Architectural Review and
Historic Preservation Board
Agenda Report

File: AR 16-09

RE: Architectural Review 16-09 (Aguilar/Souza) – Nord Avenue Apartments, 557 Nord Avenue

SITE PLAN
 1" = 50'-0"

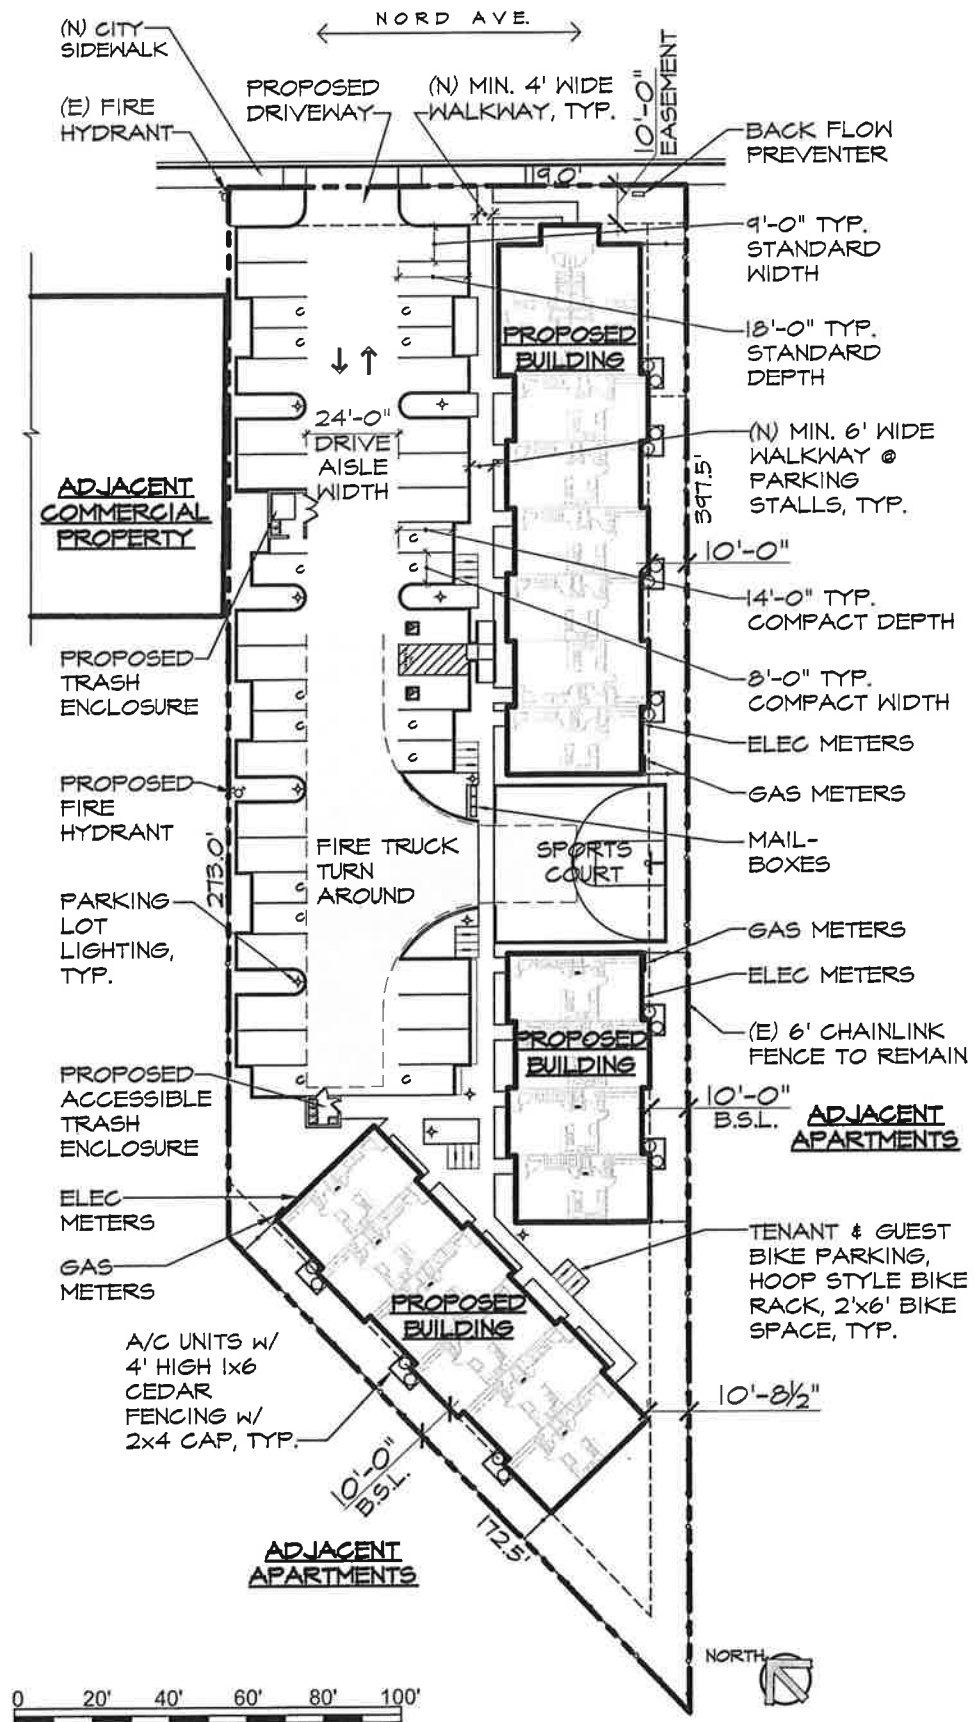
Standard parking lot requirements are satisfied, including five separate bike racks located throughout the site, and two trash enclosures (see site plan, **Attachment C**). Existing chainlink fencing is noted on the site plan to remain, however, staff has received the applicant's concurrence to replace the existing fencing with new six-foot wood fencing (see recommended

1. The southwest corner of the 4-plex building appears crowded with the 6-plex building. Discuss ways to increase the separation of the buildings by perhaps breaking up the 6-plex into two buildings, or shifting the 4-plex a few feet easterly into the sports court.
2. Discuss the feasibility of utilizing the rear of each building for passive recreation and landscape accordingly.

2. All ground-mounted HVAC shall be structurally screened as noted on all final site and landscape plans.
3. The final landscape plan shall indicate creeping vines against trash enclosure stucco walls.

4. The final site and landscape plans shall note and illustrate all existing chainlink fencing to be removed and replaced with six-foot tall wood fencing and dimensional cap around the perimeter of the site.

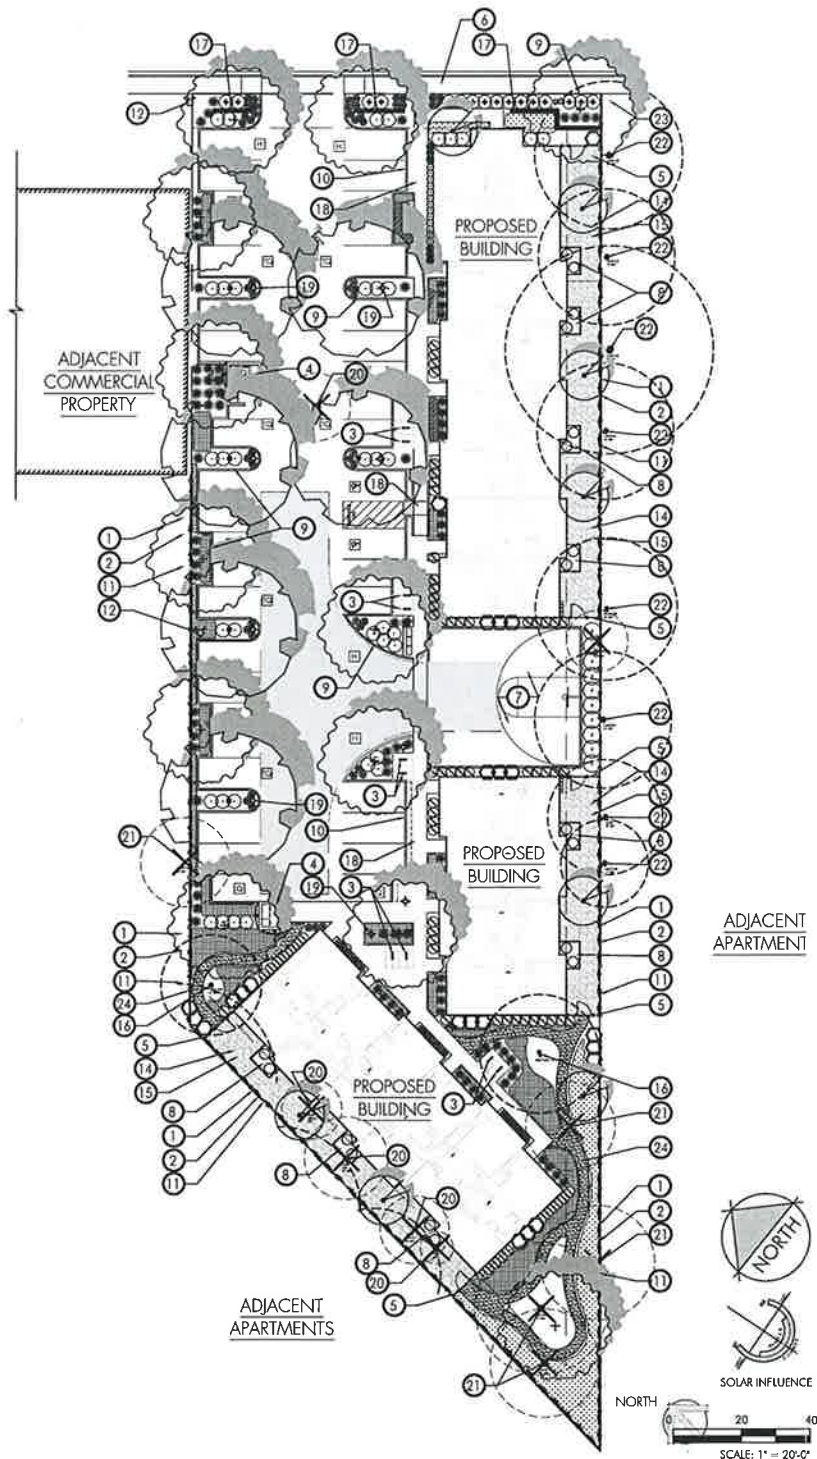
Chinese pistache and Canary Island pine trees create 67 percent shading in the parking lot yards (see landscape plans, **Attachment G**). For amenity value and to enhance an established character of the site, a mature valley oak tree will be preserved in a landscape island near the southwest corner of the site. The rear yards of each building are noted on the landscape plans as gated maintenance corridors and minimally landscaped with decomposed drain rock and intermittent crape myrtle trees. Landscape plan details (illustrated on the second page L-0.2) include dry-stack fieldstone walls for aesthetic sense-of-place along the project's street frontage, and wood fence details (which is recommended to replace all existing chain link fencing, as well as where noted on the landscape plans). Pedestrian paths are illuminated by 42-inch tall bollard fixtures, and the parking lot is illuminated by 12-foot tall full-cut off fixtures (see landscape plan for locations, and cut sheets, **Attachments H** and **I**).

5. A note in bold type face shall be included on the final landscape plans attached with all building plan sets that the valley oak tree to be preserved near the southwest corner of the site shall be preserved in accordance with Chico Municipal Code sections 16.66.110 and 19.68.060. A tree preservation plan, including fencing around the drip line and methods for excavation, shall be prepared by the project landscape architect for review and approval by planning staff prior to any ground-disturbing activities.
